**ADDENDUM - QUESTIONS AND ANSWERS # 1**

<b>Sujet - Title :</b> Replacement of six (6) wastewater Treatment systems – Phase 4	
<b>No. de l'invitation - Solicitation No.</b> 5P201-18-0016/A	<b>Date</b> March 26, 2018
<b>No de référence de SEAG -GETS Reference No.</b> PW-18-00819356	
<b>No. de référence du client - Client Reference No. –</b>	
<b>L'invitation prend fin – Solicitation Closes</b>  à – at <b>2:00 PM</b> le – on <b>Wednesday,</b> <b>April 4, 2018</b>	<b>Fuseau horaire - Time Zone</b>  Eastern Daylight Time (EDT)
<b>Adresser toute demande de renseignements à : - Address Inquiries to:</b>  Marilyn Bernier - <a href="mailto:Marilyn.Bernier@pc.gc.ca">Marilyn.Bernier@pc.gc.ca</a>	
<b>No de téléphone - Telephone No.</b>  (418) 648-4569	<b>No de FAX: - Fax No.</b>  (418) 649-6971
<b>Destinations des biens, services et construction: Destination of Goods, Services, and Construction:</b>  Mauricie National Park	
<b>Raison sociale et adresse du fournisseur/de l'entrepreneur : Vendor/Firm Name and Address</b>

**MODIFICATION DE SOUMISSION No.1  
AMENDMENT TO TENDER**

Projet - Project  
Replacement of six (6) wastewater Treatment systems – Phase 4

INSTALLATION DES TUYAUX EN  
POLYÉTHYLÈNE HAUTE DENSITÉ (PEHD),  
ASSISE EN MATÉRIEAUX GRANULAIRES  
(RÉSEAU ROUTIER)

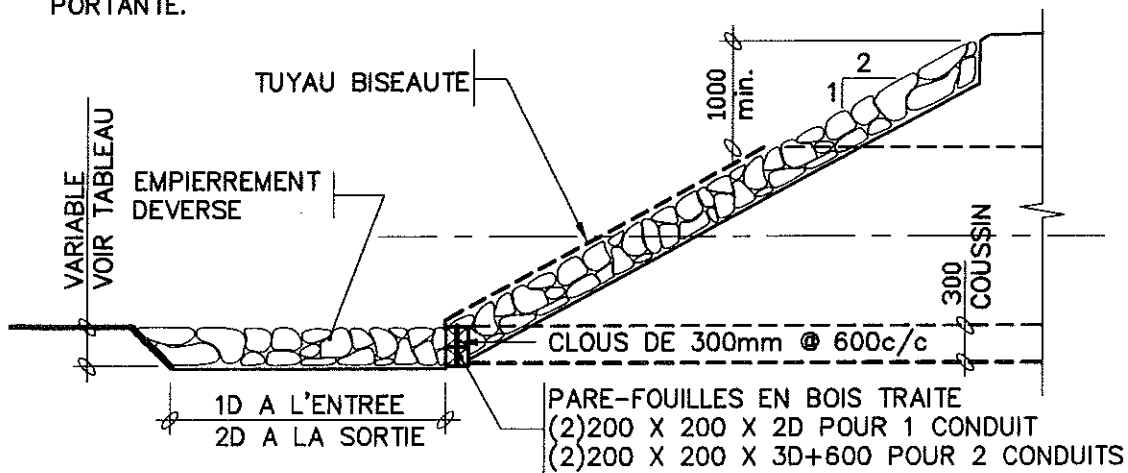
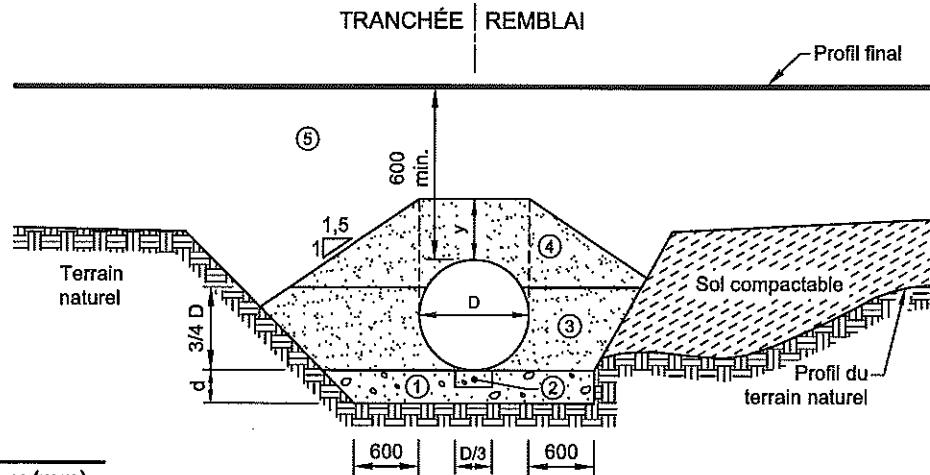
- 1) *Is there a conflict between the sewage pipe from the garage septic tank (Site 1 and 23) and the existing culvert TTP 600 mm Ø?*

Yes, there is indeed a conflict. The existing culvert will need to be replaced with a 600 mm diameter HDPE culvert. This culvert will be provided by the Parks Canada Agency (PCA) but must be installed by the Contractor as described in the attached standard drawing, including rip rap at the ends.

***This price remunerates with a fixed price all measures, actions and supplies required such as, but not limited to, management, labour, equipment, materials, permits, professional services, excavation, bedding, embedding, backfilling, over-trenching, pavements, cutoffs, geotextile membrane, the installation of a 600 mm diameter HDPE culvert to be provided by PCA to replace the existing TTP 600 mm culvert and locate on the plans. The entrance invert of this culvert will be identical to the existing one and the outgoing invert will be installed at elevation +/- 152.65 m so that the gravity sewer pipe coming from the septic tank of the garage can pass above this culvert. The installation of this culvert must be done as described in the attached standard drawing.***
